Staff Report to the
Municipal Planning Board
May 17, 2022

MPL2022-10025

MODERA BALDWIN PARK

Following the distribution of the May 2022 MPB packets and staff reports, Growth Management revised the language on conditions of approval for the proposed development. This Addendum clarifies the conditions of approval found on page 18 of this report.

DEVELOPMENT PLAN

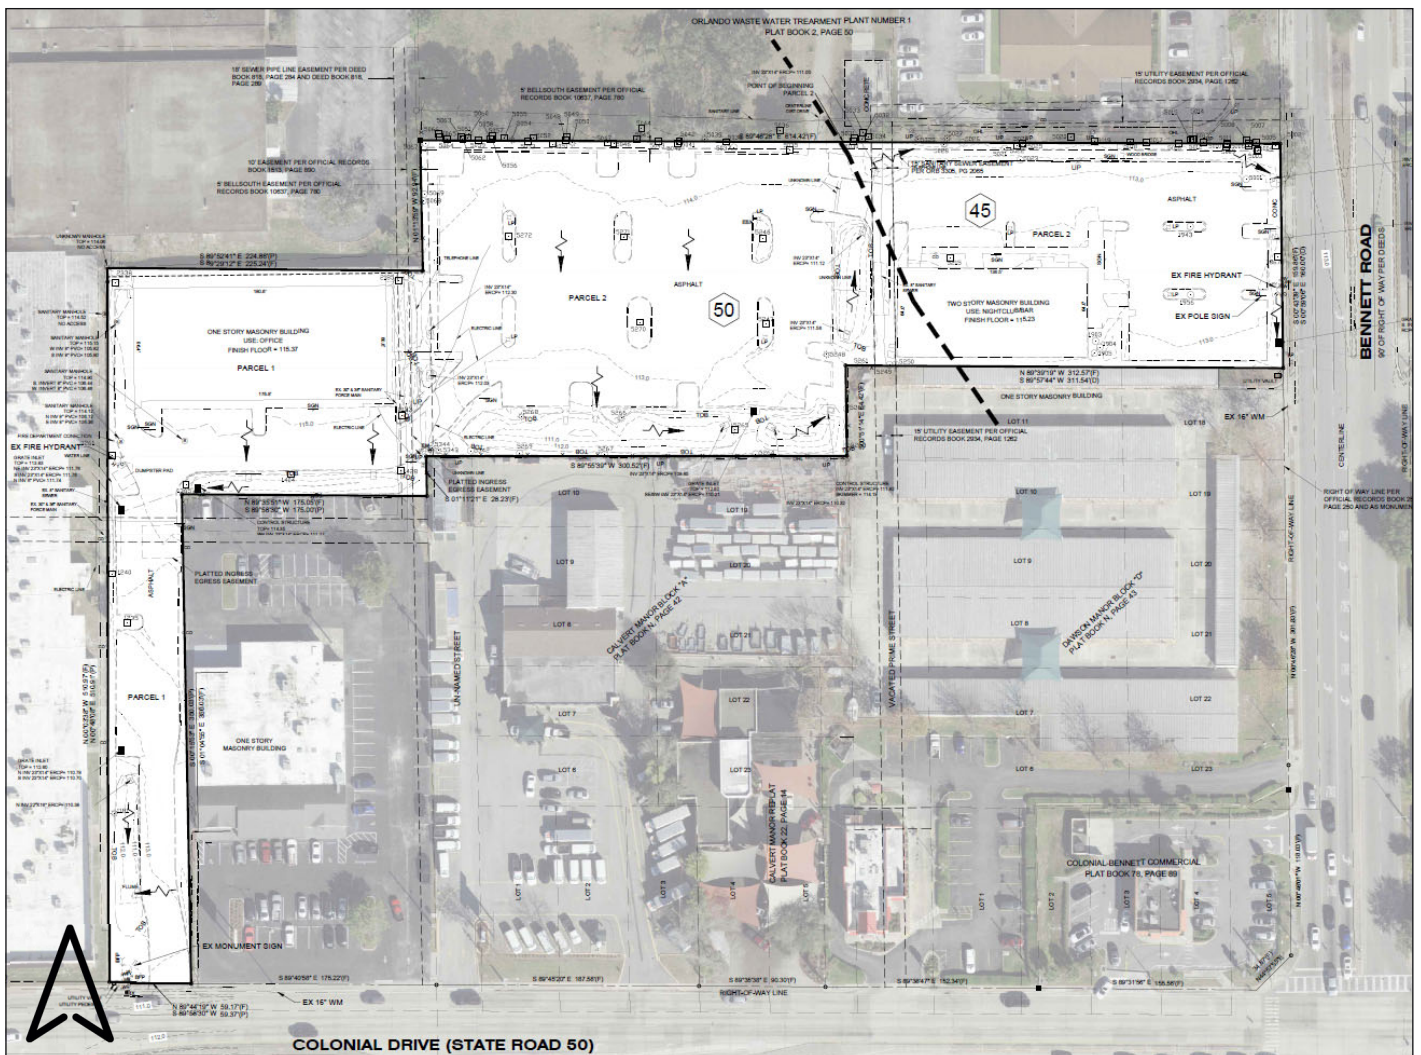
7. North-South Driveway Design: The north-south driveway and parking area coming from E Colonial Dr. into the site must be redesigned to incorporate sidewalks on each side of the driveway. To accommodate this the parking can be reoriented to be parallel spaces (min 8 ft. wide with up to 1 ft. in the gutter), 2 - 10 ft. travel lanes, 6 ft. sidewalks along each side and the remainder of the space to accommodate landscaping.

11. Internal Pedestrian Circulation: The pedestrian circulation plan must be updated to provide connections between all buildings with the on-site sidewalks system. As shown there are many gaps between sidewalks for adjacent buildings.

- b. Parking space design: All parking spaces must be marked and designed in accordance with CH 61, Part 3 of the LDC. As shown "regular" spaces are shown as 18 ft. in depth where they are required to be 18.5 ft. in depth; the drive aisle may be reduced to 23 ft. to accommodate the additional parking space depth. Compact spaces must meet the requirements of LDC Sec. 61.309 b.

BUILDINGS ELEVATIONS

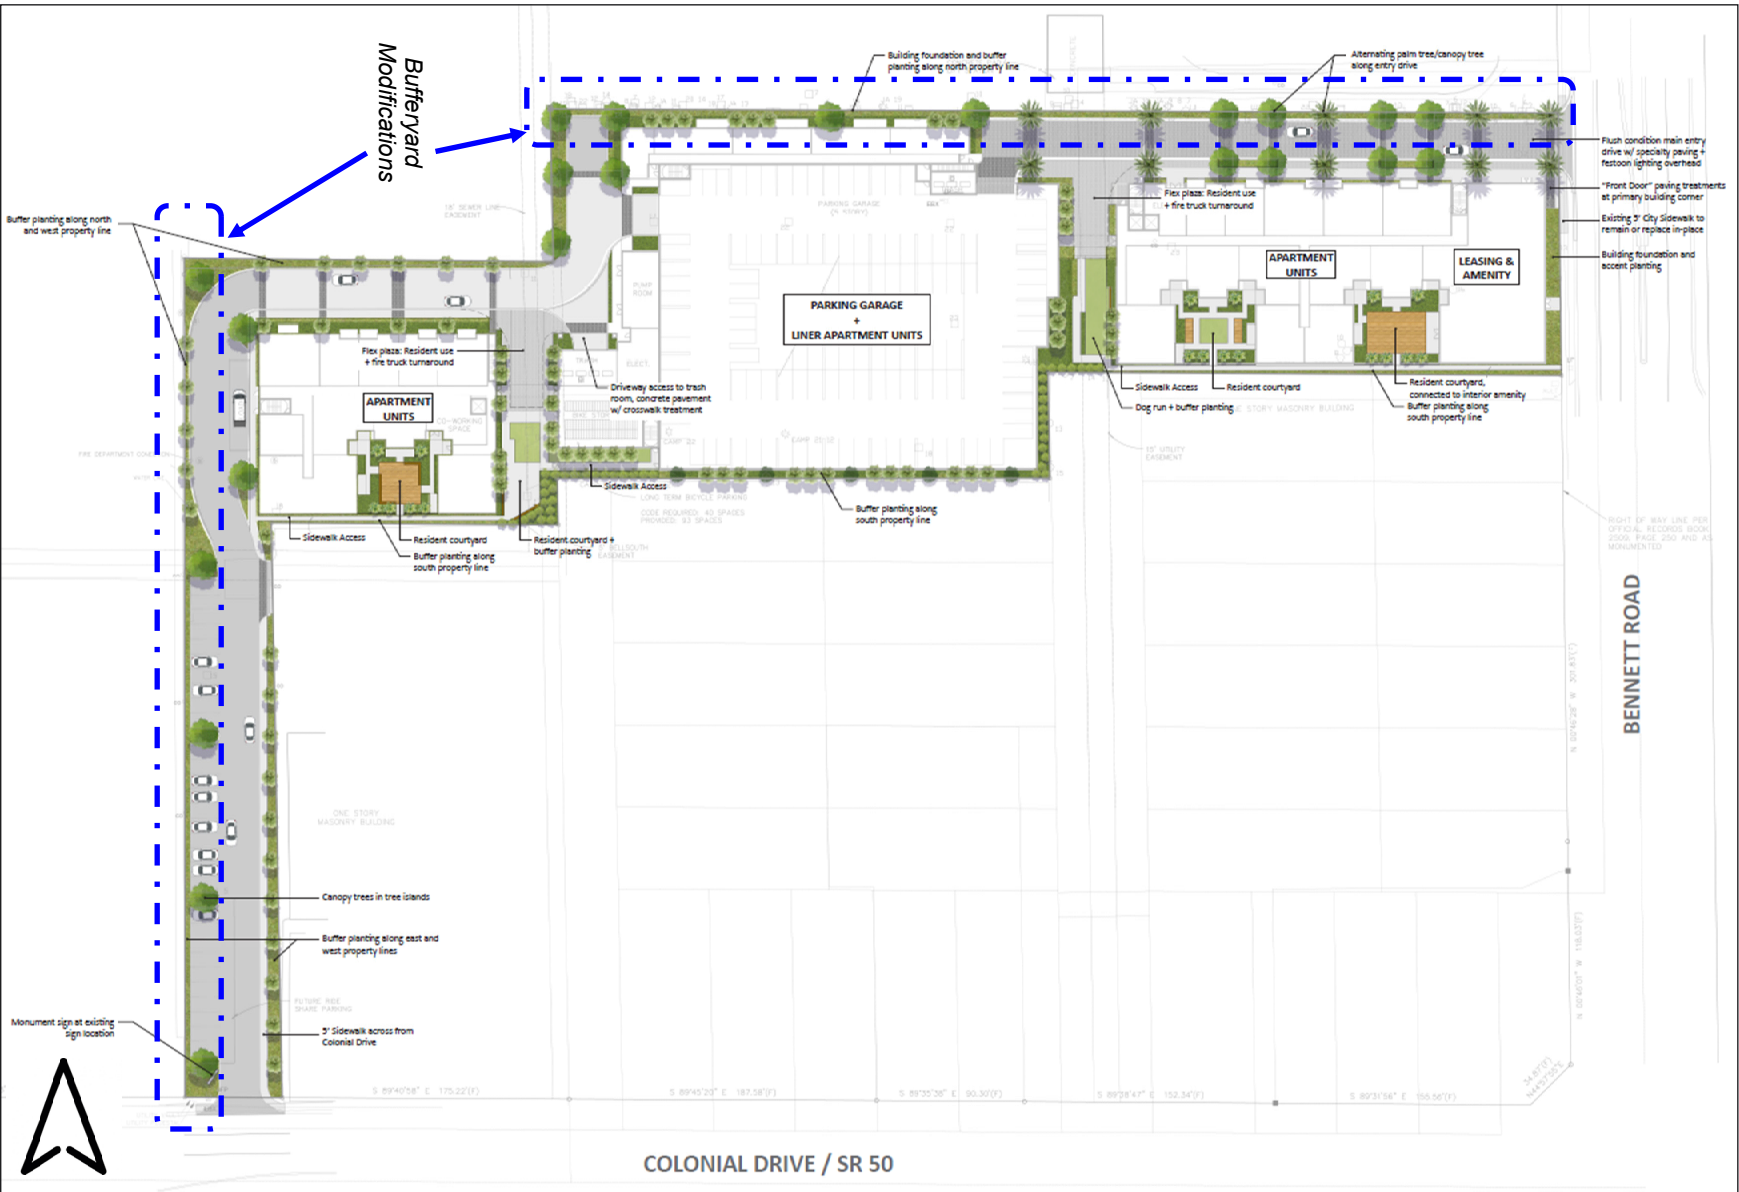
4. Parapets must have a 3-D appearance and be at minimum as tall as the rooftop mechanical equipment.
5. All architectural details proposed must be executed so that they add to the overall design of the building. For example, all trim details, including window trims, must be raised from the surface of the building, also all scoring proposed for the building must be deep enough so that the scoring provides shadow lines and reads from the pedestrian environment.

6. The parking garage will be seen from E Colonial Dr. Finishing materials and colors from the principal buildings must be carried through the garage southern facade, to soften and blend the garage with the residential buildings. Screening of the garage openings can be a faux mullion patterns to mimic the rhythm and design of the residential buildings window design. Vehicle headlights must be screened with a solid wall, 48 inches tall at minimum.
